Access Compliance Report

Public Rights-of-Way

Intersection ID: 20923	Main Street: LANSLOWNE_RD	Cross Street: OWENBY_CT	Location: E
ADA ID: 46B461D68C28	Ramp Type: PerpDiag	Initial Pass/Fail: Fail	Overall Compliance: No
Codes/Mitigation Info/Possible Solution		Field Measurements/Component Compliance	
Severity Score: 13.75

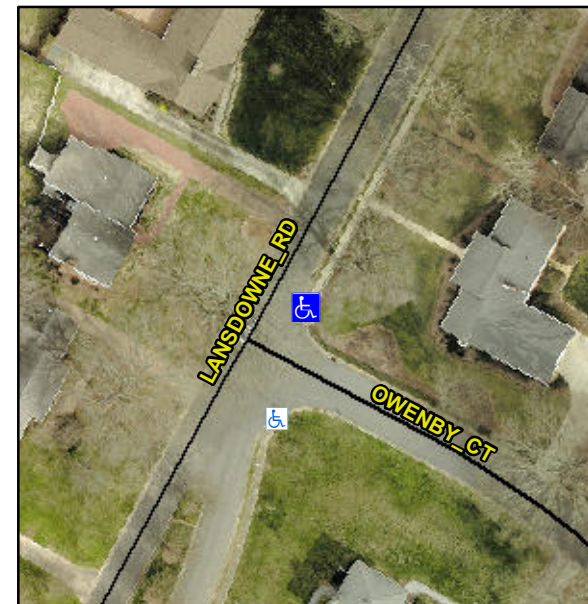
Not Found, R304.2.2, R304.5.3

Compliance	Description	Data	Compliance	Description	Data
N/A	Ramp Length (in)	48.0	No	Ramp Slope (%)	10.4
Yes	Ramp Width (in)	48.0	No	Ramp XSlope (%)	2.4
N/A	Flare Type LT	N/A	N/A	Flare Type RT	N/A
N/A	Flare Slope LT (%)	N/A	N/A	Flare Slope RT (%)	N/A
N/A	Flare Traversable LT?	N/A	N/A	Flare Traversable RT?	N/A
N/A	Landing Length (in)	N/A	N/A	DWS Provided?	N/A
N/A	Landing Width (in)	N/A	N/A	DWS Contrast?	N/A
N/A	Landing Slope (%)	N/A	N/A	DWS Length (in)	N/A
N/A	Landing X Slope (%)	N/A	N/A	DWS Full Width?	N/A
N/A	Landing Curb? (Y/N)	N/A	N/A	DWS Offset (in)	N/A
N/A	Shared Landing?	N/A			
N/A	Gutter Ponding?	N/A	N/A	Gutter Slope (%)	N/A
N/A	Gutter Lip Ht (in)	N/A	N/A	Gutter X Slope (%)	N/A
N/A	Painted X Walk1?	No	N/A	Painted X Walk2?	No
	X Walk 1 Direction	To NW		X Walk 2 Direction	To SW
N/A	X Walk 1 Width (in)	N/A	N/A	X Walk 2 Width (in)	N/A
	X Walk 1 Slope (%)	5.8		X Walk 2 Slope (%)	1.1
	X Walk 1 X Slope (%)	1.4		X Walk 2 X Slope (%)	1.7

Remove & Replace Curb Ramp With Two New Directional Ramps or Equivalent.
